Access Compliance Report

Public Rights-of-Way

Intersection ID: 9396	Main Street: MORETZ_AV	Cross Street: N_GRAHAM_ST	Location:	E
ADA ID: 3E2B18EA4F52	Ramp Type: Perp	Initial Pass/Fail: Fail	Overall Compliance: No	Severity Score: 37.5
Codes/Mitigation Info/Possible Solution		Field Measurements/Component Compliance

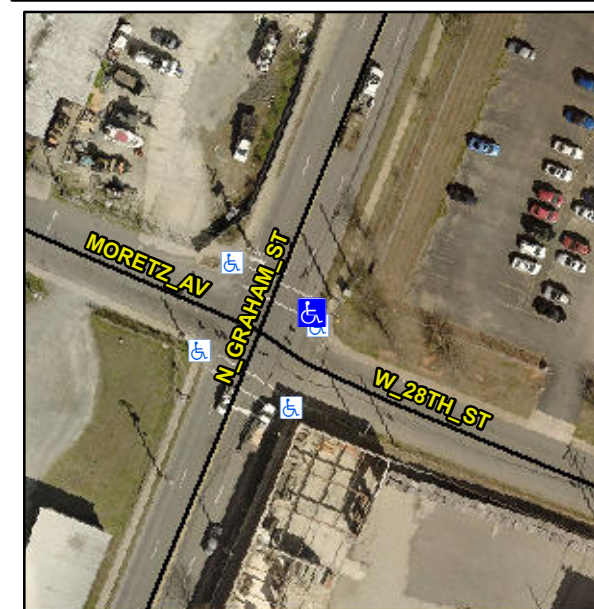
R304.5.1, R304.2.2, R304.5.3, R302.7

Compliance	Description	Data	Compliance	Description	Data
N/A	Ramp Length (in)	56.5	No	Ramp Slope (%)	9.8
No	Ramp Width (in)	44.0	No	Ramp XSlope (%)	3.7
N/A	Flare Type LT	N/A	N/A	Flare Type RT	N/A
N/A	Flare Slope LT (%)	N/A	N/A	Flare Slope RT (%)	N/A
N/A	Flare Traversable LT?	N/A	N/A	Flare Traversable RT?	N/A
N/A	Landing Length (in)	N/A	N/A	DWS Provided?	N/A
N/A	Landing Width (in)	N/A	N/A	DWS Contrast?	N/A
N/A	Landing Slope (%)	N/A	N/A	DWS Length (in)	N/A
N/A	Landing X Slope (%)	N/A	N/A	DWS Full Width?	N/A
N/A	Landing Curb? (Y/N)	N/A	N/A	DWS Offset (in)	N/A
N/A	Shared Landing?	N/A			
N/A	Gutter Ponding?	N/A	N/A	Gutter Slope (%)	N/A
N/A	Gutter Lip Ht (in)	2.0	N/A	Gutter X Slope (%)	N/A
N/A	Painted X Walk1?	Yes	N/A	Painted X Walk2?	N/A
	X Walk 1 Direction	To NW		X Walk 2 Direction	N/A
N/A	X Walk 1 Width (in)	111.5	N/A	X Walk 2 Width (in)	N/A
	X Walk 1 Slope (%)	2.2		X Walk 2 Slope (%)	N/A
	X Walk 1 X Slope (%)	1.4		X Walk 2 X Slope (%)	N/A

N/A	Ramp inside XWalk1?	Yes	N/A	Ramp inside XWalk2?	N/A
	Road Slope (%)	N/A	N/A	Clear Space?	N/A
	Road X Slope (%)	N/A	N/A	Clear Space to XWalk (in)	N/A
N/A	Any Obstructions?	N/A	N/A	Storm Grate/Utility Hazard?	N/A
	Obstruction Type			Storm Grate/Utility Type	
		N/A			N/A
		No		Surface Condition? (G/P)	Poor

Remove & Replace Entire Ramp.
